## **304 GOVERNMENT STREET SUBDIVISION**

APPLICATION NUMBER 6 DATE April 17, 2014

APPLICANT 304 Government Street Subdivision

# DETAIL SITE PLAN

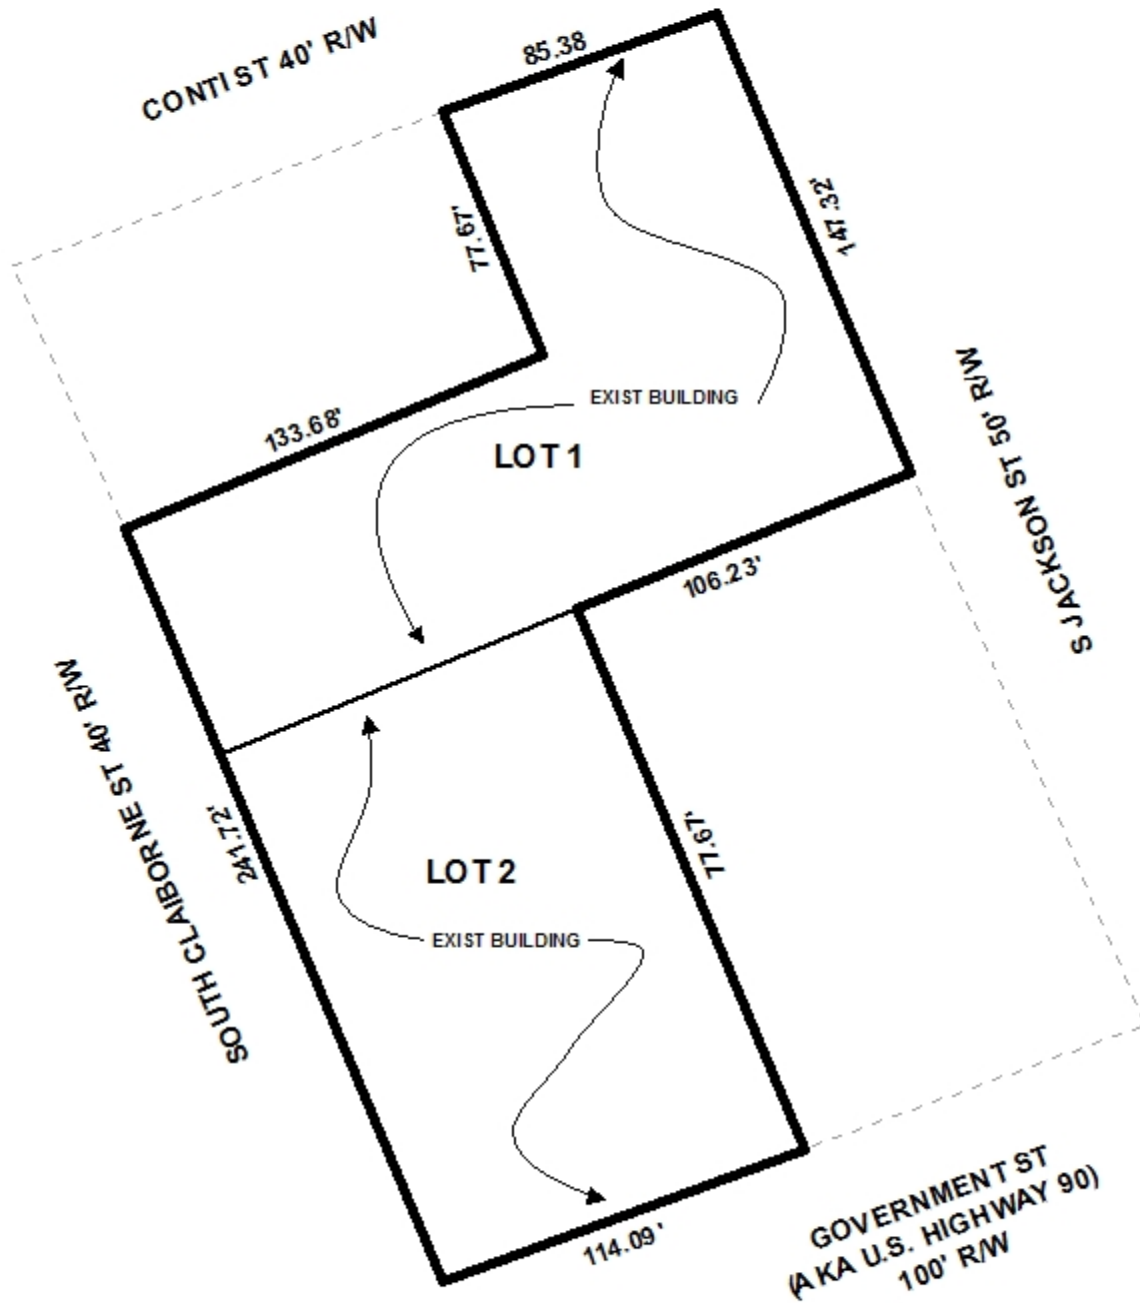
- A. Provide all of the required information on the SUBDIVISION PLAT (i.e. signature blocks, signatures, certification statements, written legal description, required notes, legend, scale, bearings and distances).

- B. Add a note to the SUBDIVISION PLAT stating that a Land Disturbance permit will be required for any land disturbing activity in accordance with the of the Storm Water Management and Flood Control Ordinance (Mobile City Code, Chapter 17 , Ordinance #65-007 & #65-045), latest edition. Storm water detention may be required for any existing development (since 1984) that did not receive Land Disturbance permitting and for any future addition(s) and/or land disturbing activity.

- C. Add a note to the SUBDIVISION PLAT stating that as shown on the 1984 aerial photo (FLIGHT 30 - #71) each lot will receive historical credit of impervious area towards storm water detention requirement per the Storm Water Management and Flood Control Ordinance (Mobile City Code, Chapter 17, Ordinance #65-007 & #65-045), latest edition. Coordinate with City Engineering Department staff to establish the exact amount prior to the submittal of the Land Disturbance Permit application.

- D. Add a note to the Plat stating that the approval of all applicable federal, state, and local agencies (including all storm water runoff, wetland and floodplain requirements) will be required prior to the issuance of a Land Disturbance permit.

- E. Dedication of the corner radius (25' minimum or as approved by the City Engineer and Traffic Engineer) at the corner of Claiborne Street and Government Street.

- F. Show and label all flood zones.
- G. Show and label the MFFE (Minimum Finished Floor Elevation) on each lot that contains an AE, V, or X (shaded) flood zone designation.

- H. Provide and label the monument set or found at each subdivision corner.
- I. Provide the Surveyor's, Owner's (notarized), Planning Commission, and Traffic Engineering signatures.

- J. Remove the County Engineer's signature block from the Plat. The County Engineer no longer signs plats within the municipal limits of the City of Mobile.

With waivers of Sections V.B.14. and V.D.9. of the Subdivision Regulations, the application is recommended for tentative approval, subject to the following conditions:

- 1) Waiver of the corner radius provisions of Section V.D.6. of the Subdivision Regulations, subject to Traffic Engineering and Engineering approvals;

- 2) Retention of the lot size in square feet and acres on the Final Plat;
- 3) Placement of a note on the Final Plat stating that both lots are limited to the existing curb-cuts with any changes to the size, design or location to be approved by Traffic Engineering, Engineering and ALDOT (as appropriate), and conform to AASHTO standards;

- 4) Placement of a note on the Final Plat stating: *(Development of the site must comply with local, state and federal regulations regarding flood zones.);*
